# SERVICE BULLETIN

from: TRIO-KENWOOD COMMUNICATIONS, INC.

SUBJECT: TS-180S DFC INSTABILITY

DATE 7/13/79

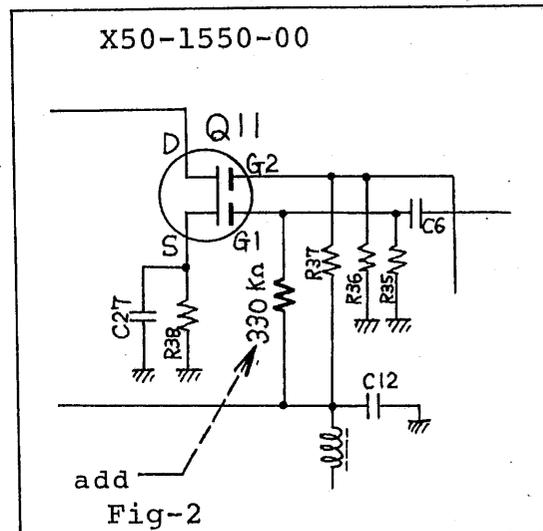
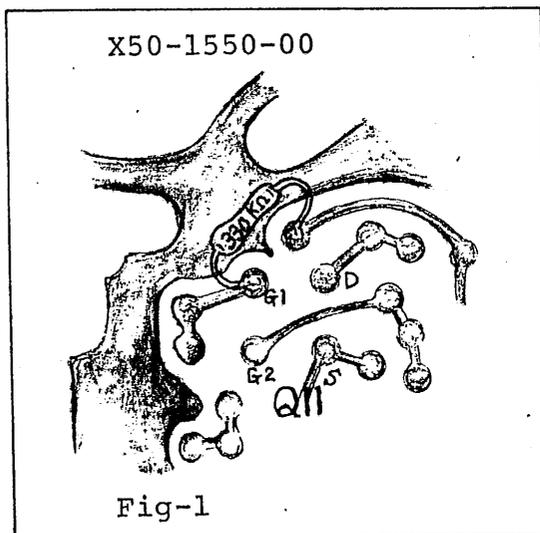
TS-180S operators may report intermittent DFC instability, especially at 10Khz even points. This may be characterized in some cases as FM'ing.

On the VCO unit X50-1550-00, install a 330K ohm resistor between Q11 G1, and the 8V line. Connect from L7 at C12 to Q11 G1, at R35.

No adjustments are necessary.
